PROJECT REFERENCE NO. U-4405	SHEET NO. UC-44
DESIGNED BY: AMH	
DRAWN BY: AMH/AB	
CHECKED BY: AMH	
APPROVED BY: MWF	
REVISED:	
NORTH CAROLINA DEPARTMENT OF TRANSPORTATION UTILITIES ENGINEERING SEC. PHONE: (919) 707-6690 FAX: (919) 250-4151

### UTILITY CONSTRUCTION

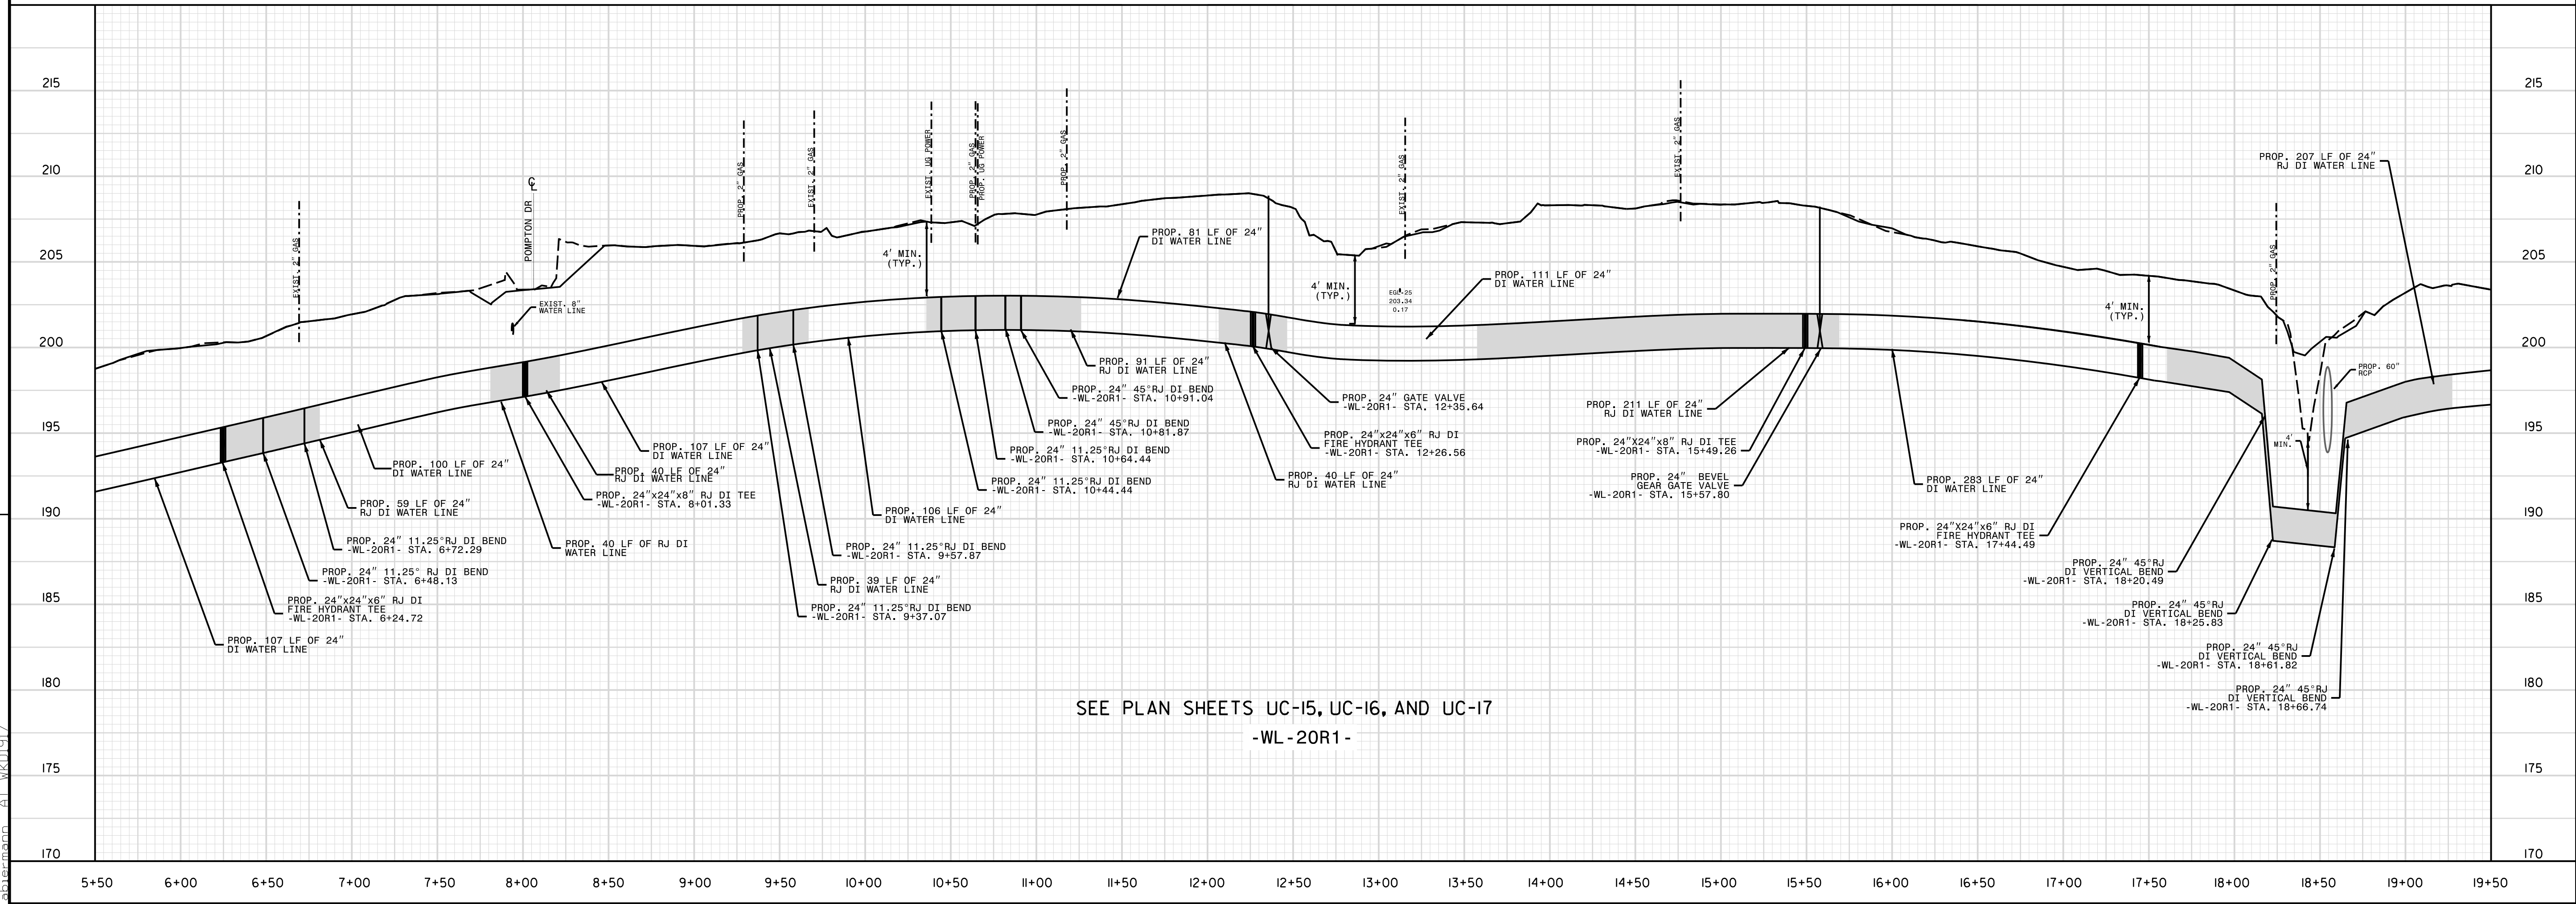
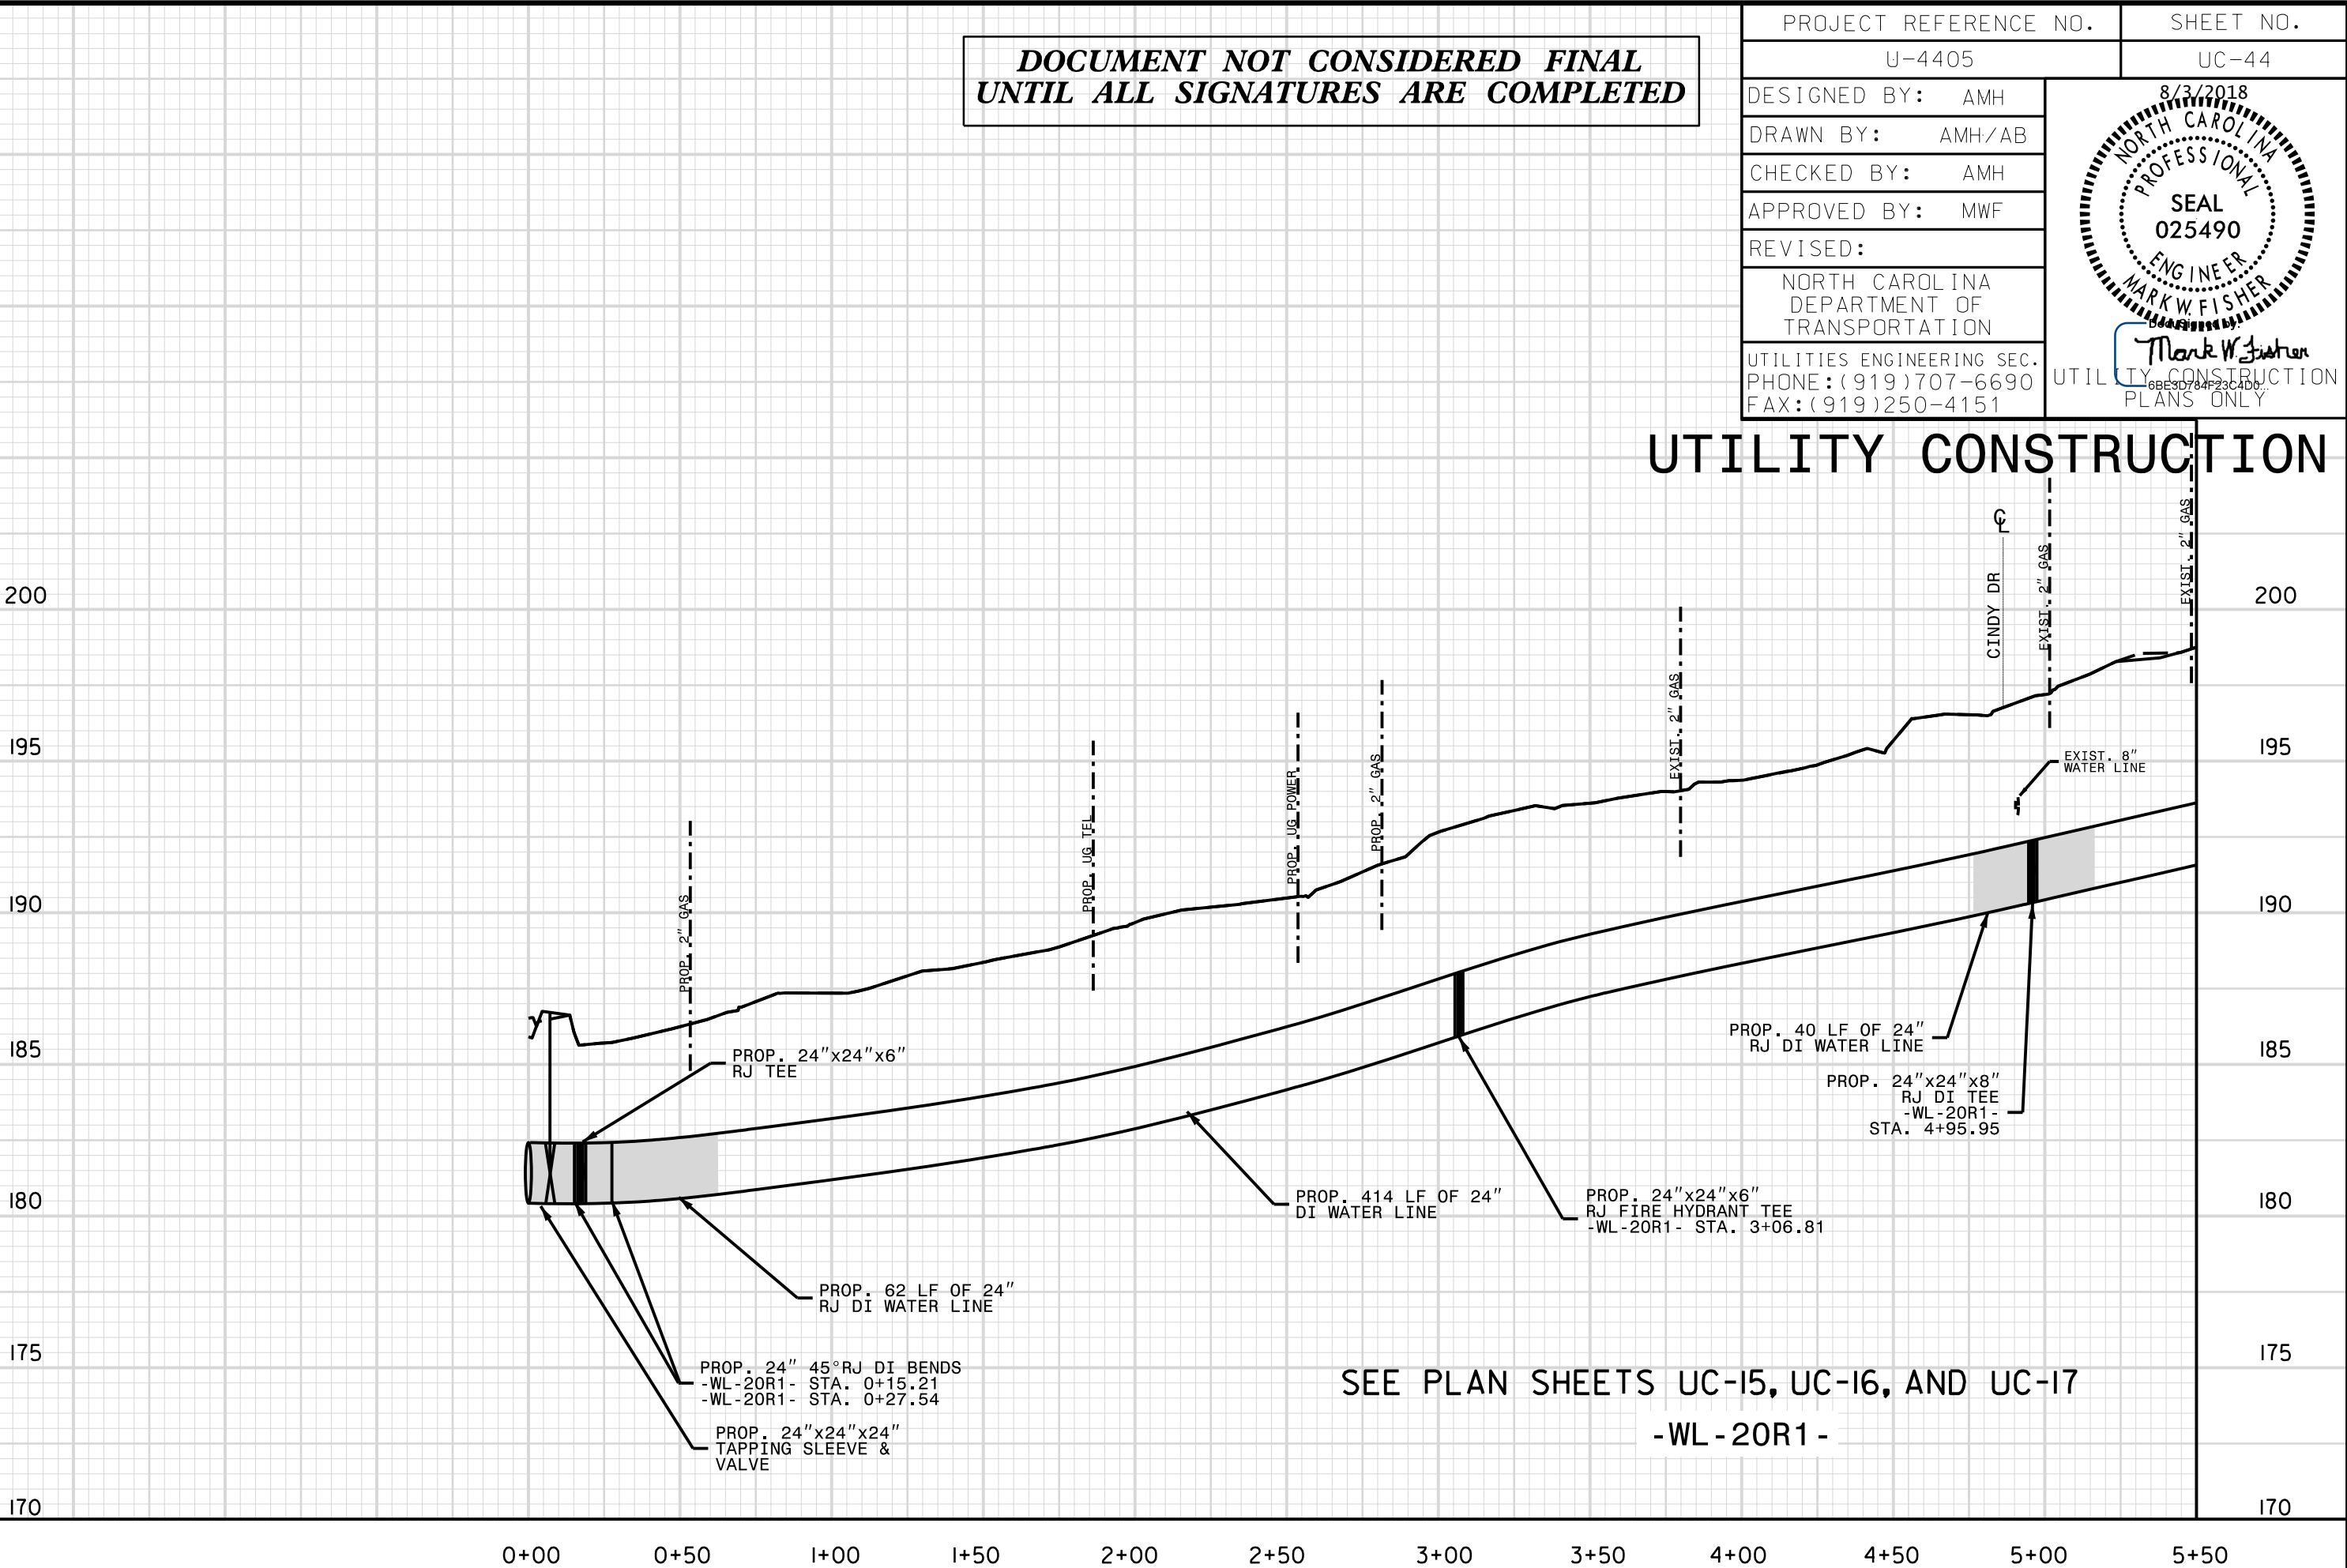
REVISIONS  
 UTILITY REV. - JULY 24, 2008 - SHIFTED VALVE FROM STA. 4+36 TO STA. 4+24  
 - ADDED 80 LF OF R/DIP BEFORE VALVE AT WL-19C STA. 8+24.34  
 - ADDED 200 LF OF R/DIP BEFORE TEE AT WL-20R1 STA. 15+49  
 27 JUL 2008 4:59  
 Public Works Commission (2015017700RA Reeford Road NCDOT PLANS\Utilities\Engineering\UC\Proc\U4405\UCADD\NCDOT PLANS\Utilities\ut\_pf1\_uc44\_psh.dgn  
 8/28/08
